## LAND USE APPLICATION SUMMARY

*Property Location:* 612 32<sup>nd</sup> Street West  
*Project Name:* 612 32<sup>nd</sup> Street West Driveway  
*Prepared By:* [Janelle Widmeier](#), Senior City Planner, (612) 673-3156  
*Applicant:* KLP Real Estate, LLC  
*Project Contact:* Chris Casey and Jenni Trombley, CNC Construction  
*Request:* To construct a driveway to allow a surface parking space accessory to a single-family dwelling.

<b>Variance</b>	To allow a surface parking space to be located less than 6 feet from habitable space of a dwelling.
-----------------	---

# CERTIFICATE OF SURVEY

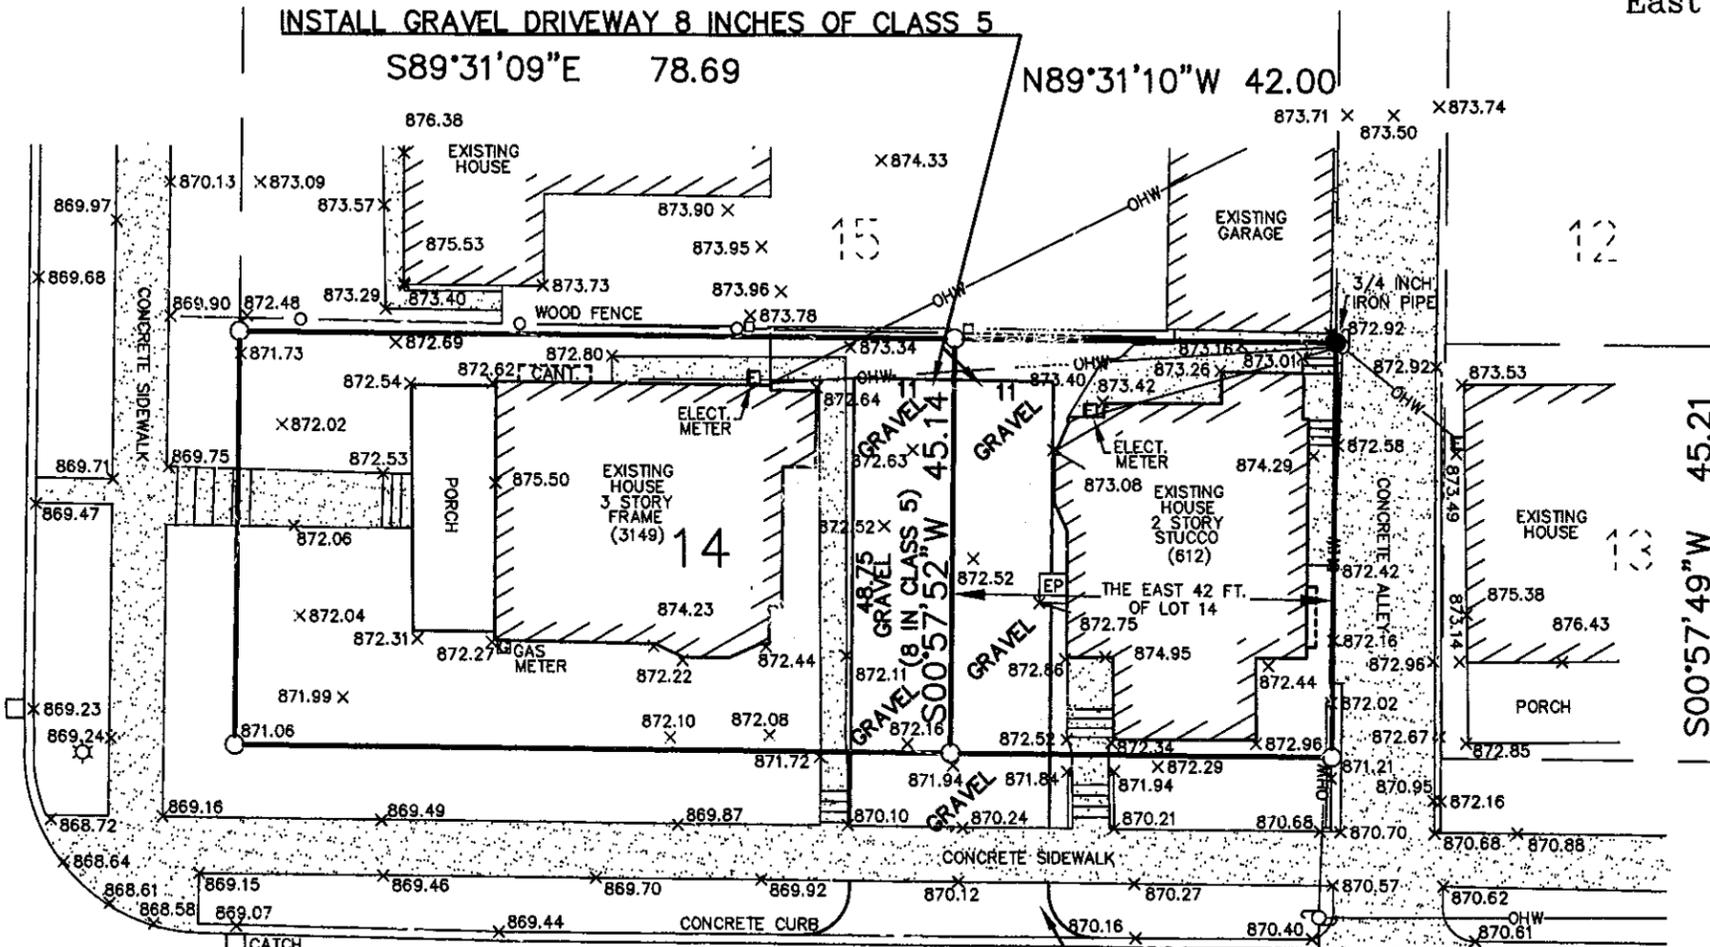
parking space for the subject property would comply with all other applicable zoning code requirements. However, the proposed parking space will have no separation from the bay window. The remainder of the parking area would be approximately 1.5 feet from the dwelling. With the parking space proposed on the adjacent property, the total parking area width is proposed at 22 feet. The zoning code only requires 8.5 feet of width for standard parking spaces. Because the applicant owns both properties, the overall parking area width could be reduced to allow some separation from both dwellings while still accommodating 2 parking spaces. The proposed width of the driveway and curb cut could also result in tandem parking. The minimum front yard requirement adjacent to 32<sup>nd</sup> Street is 15 feet. Parking is not permitted in a required front yard. If the driveway is narrower at the public sidewalk and then flares out to the paved parking spaces, then it is less likely that cars will park in the required front yards. Some grade modifications adjacent to the public sidewalk are also likely needed. Narrowing the driveway should also result in a less abrupt grade change between the driveway and walkway and steps and leaves more room for on-street parking. Therefore, CPED staff is recommending that the parking area is located at least 3 feet from the subject dwelling (resulting in a combined parking area width of 19 feet across both properties) and that the total combined driveway/curb cut width serving both properties not exceed 14 feet at the public sidewalk. With the adoption of the staff recommendation, the request is reasonable and consistent with the intent of the ordinance and the comprehensive plan.

The proposal to allow one parking space for the subject property would also comply with all other applicable zoning code requirements. However, the proposed class-5 gravel surfacing may result in the lack of a defined boundary for the driveway and parking area. Because there is a grade change between the parking area and public sidewalk, the class-5 surfacing is also more likely to track into the public right-of-way (ROW). Where the driveway is located in the ROW, including the 8 feet of interior boulevard between the property line and the public sidewalk, it must be paved. CPED staff is recommending that the driveway and parking area is paved on the subject property as well to address these issues. Staff is also recommending that the parking area be located at least 5 feet from the north lot line, to minimize the amount of impervious surface and to create a buffer from the adjacent property. With the adoption of the staff recommendation to locate the parking space not less than 3 feet from the subject dwelling and 5 feet from the north lot line, to narrow the driveway and curb cut, and to pave the parking area, the granting of the variance would not affect the character of the area or be injurious to the use or enjoyment of other property in the vicinity. If granted, the proposed variance will not be detrimental to the health, safety or welfare of the public or those utilizing the property.

- I. The parking space shall be located at least 3 feet from the bay window of the subject dwelling.

2. To better define the boundaries of the parking area and driveway, the surface shall be paved.
3. The total combined width of the shared curb cut and driveway at the public sidewalk shall not exceed 14 feet.
4. The parking area shall be located at least 5 feet from the north lot line.
5. Approval of the final site plan by the Department of Community Planning and Economic Development.
6. All site improvements shall be completed by May 21, 2017, unless extended by the Zoning Administrator, or the permit may be revoked for non-compliance.
